ETB Rev0 Errata List

CPU Cores Division

Document number: **ETB-PRDC-001103 17.0**
Date of Issue: 11 February 2011
Author: ARM

This document describes the known errata in the Embedded Trace Buffer design.

Figure 1: Waveform Diagram

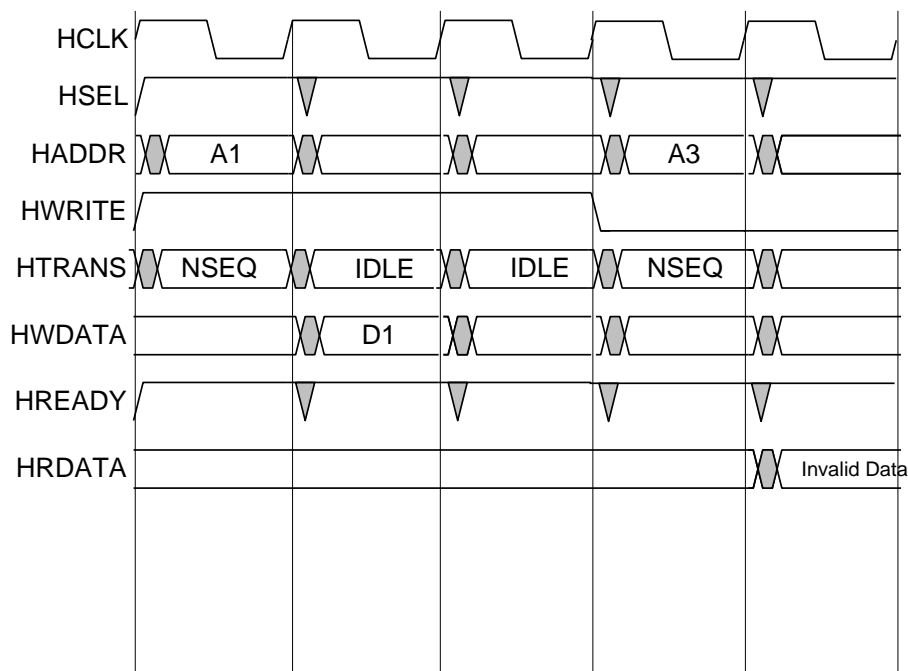
4.2.1 Description

JTAG access to the ETB is unaffected.

An undefined data value is written to the intended RAM read location and the returned read value is undefined.

There are no known workarounds for this erratum in existing designs. For new designs, this erratum can be avoided by using the ETB in asynchronous mode (by tying **SBYPASS** to 0).

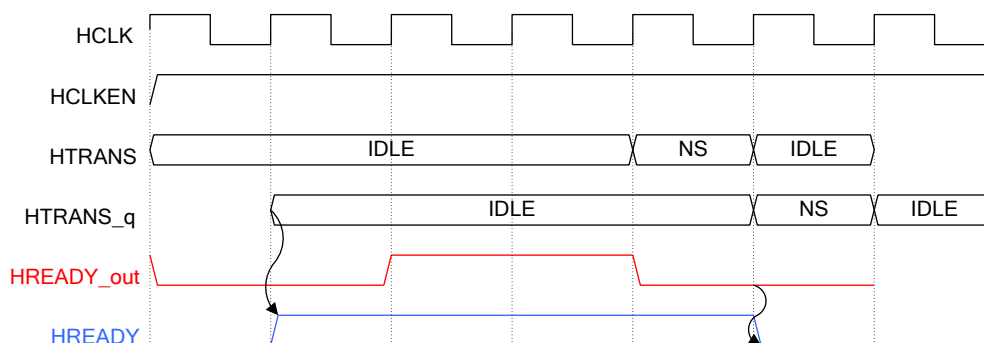
The AHB master driving the ETB might assume that IDLE or BUSY transactions will always result in a zero wait-state response. This erratum might cause the AHB master to drive a new NSEQ or SEQ transaction on the AHB interface while HREADY is low and therefore causing the ETB to miss the new transaction.

The new transaction might have incorrect data returned in the case of a read transaction, or a write transaction might be performed incorrectly in the ETB.

The HREADY output from the ETB must be qualified based on whether an IDLE or BUSY transaction is in progress. It is important that this is done during the data phase of the transfer (second cycle) and therefore a registered version of HTRANS[1] should be used. While this registered version of HTRANS[1] is b0 HREADY must be high. This is shown in the following timing diagram example illustrating an IDLE transaction:

This can be achieved with the following logic applied to HREADY output from the ETB creating a new HREADY output.
